Southern Nuclear Operating Company
Vogtle Early Site Permit Application
Safety Review Site Audit Meteorology Information Needs

1. Responses to NRC Site Meteorology Information Needs from December 2006 Safety Review Site Audit for Vogtle ESP Application
2. Response Attachments

Information Needs from the December 2006 Safety Review Site Audit

Figure 2.3-1 Climatological Observing Stations Near the VEGP Site

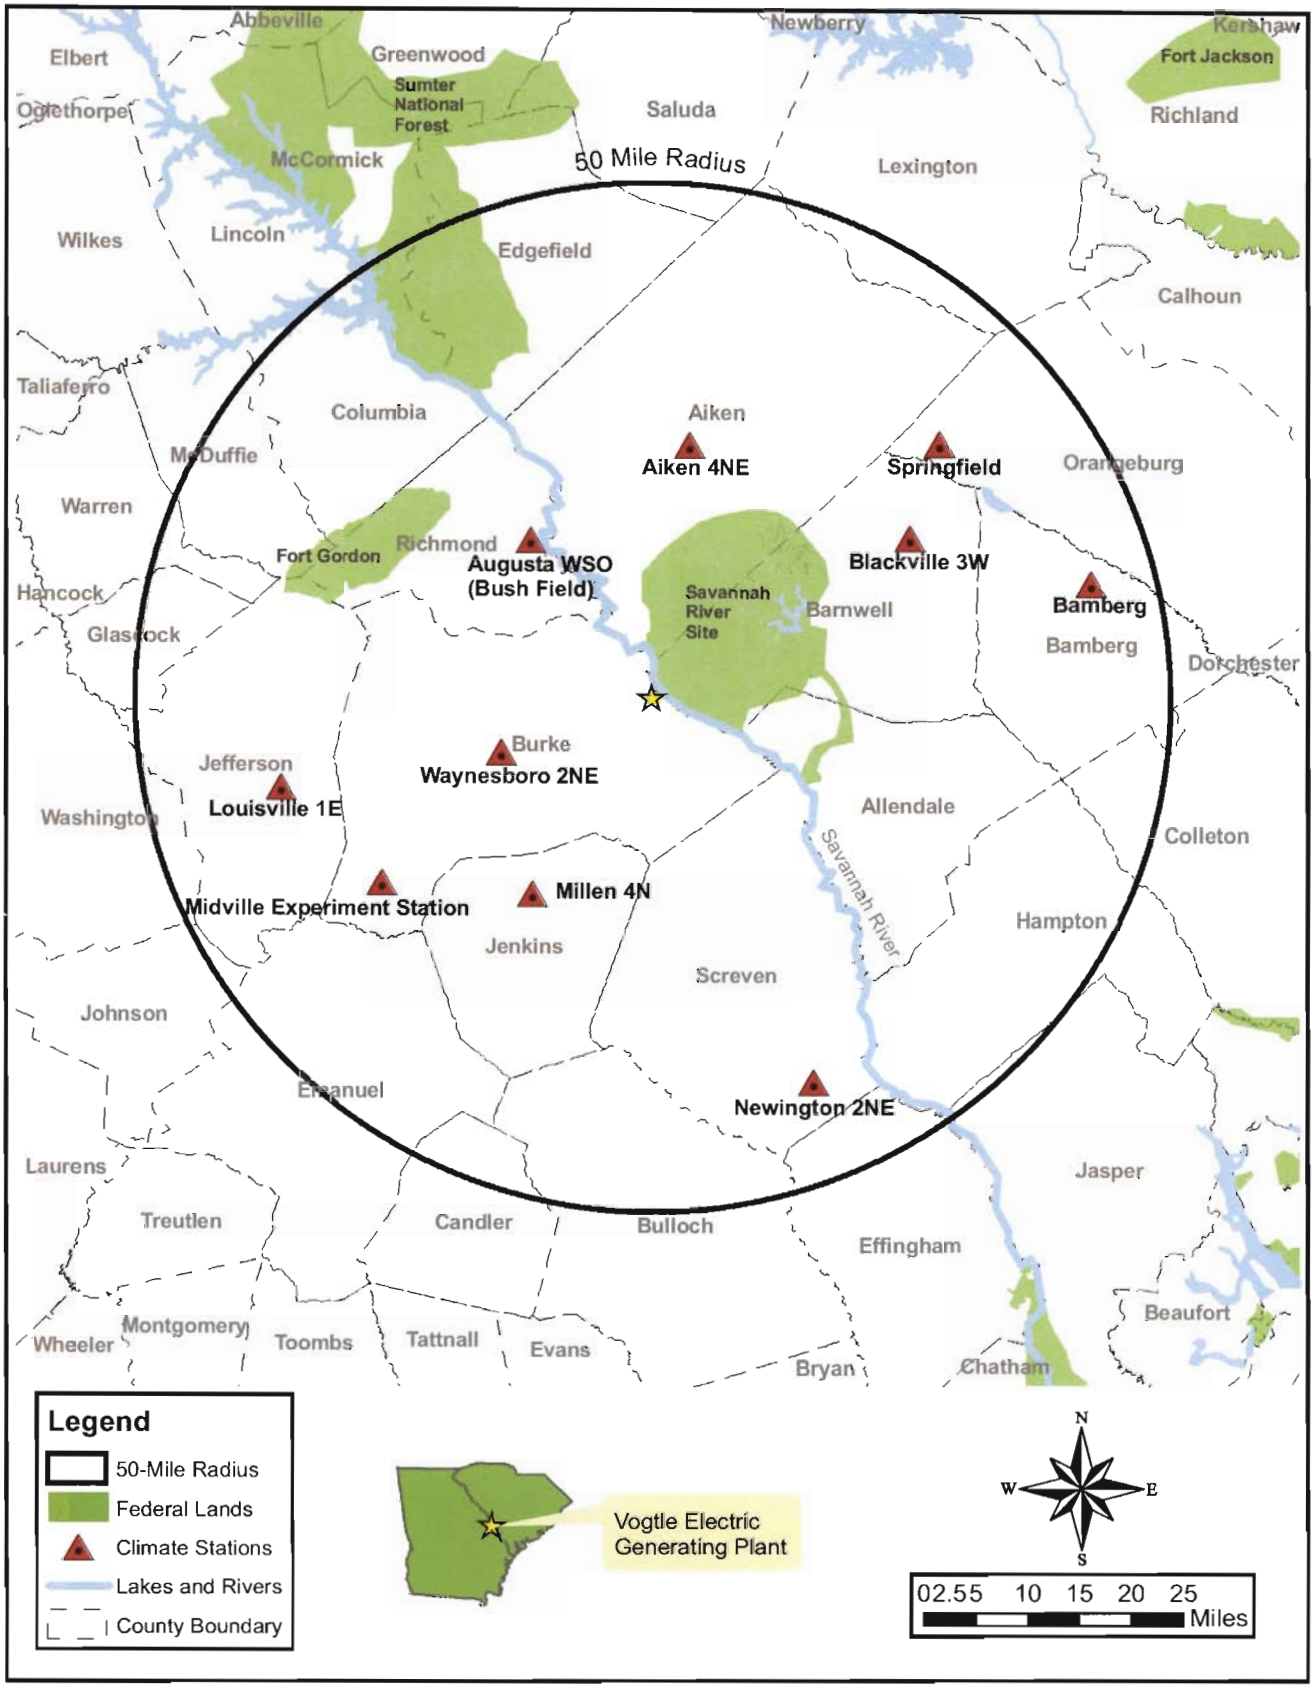
2.3.1-2 Eight climatological observing stations were used to characterize the regional climatology of the Vogtle ESP site. The staff identified a total of seventeen observing stations around (i.e. within a 50 mile radius) the Vogtle ESP site with 13 to 94 years of available data. Please explain the selection process used for the eight observation stations listed in the SSAR.

Also, upon further evaluation of the Bamberg Station record, this station will be added to Table 2.3-3 and Figure 2.3-1, despite its distance from the VEGP site (i.e., about 43.5 miles, or 70 km), because it contributes both the highest of the maximum daily and maximum monthly snowfall totals in the site area.

2.3.2-5 SSAR Section 2.3.2.2.3 states that "extreme maximum temperatures recorded in the vicinity of the VEGP site have ranged from 105oF to 110oF, with the highest reading observed at the Newington 2NE Station on July 13th, 1980." However, the staff found a higher extreme maximum temperature recorded in the vicinity of the VEGP site, 112oF, which occurred at Louisville 1E on July 24th, 1952.

The 50-mile radius circle shown in Figure 2.3-1 is only used to provide the reader with a relative indication of the distance between the climate observing stations and the VEGP site. A 50-km (about 31-mile) grid spacing is considered to be a reasonably fine mesh grid in current regional climate modeling and this distance was used as a nominal radius for the station selection process.

In evaluating the Louisville 1E station temperature records, SNC agrees with the reported overall maximum temperature value of 112°F. This station will be added to Table 2.3-3 and Figure 2.3-1 because it contributes the highest of the maximum daily temperature records in the site area despite its distance from the VEGP site (i.e., about 37 miles or 60 kilometers) exceeding the selection criteria discussed in response to Question 2.3.1-2.
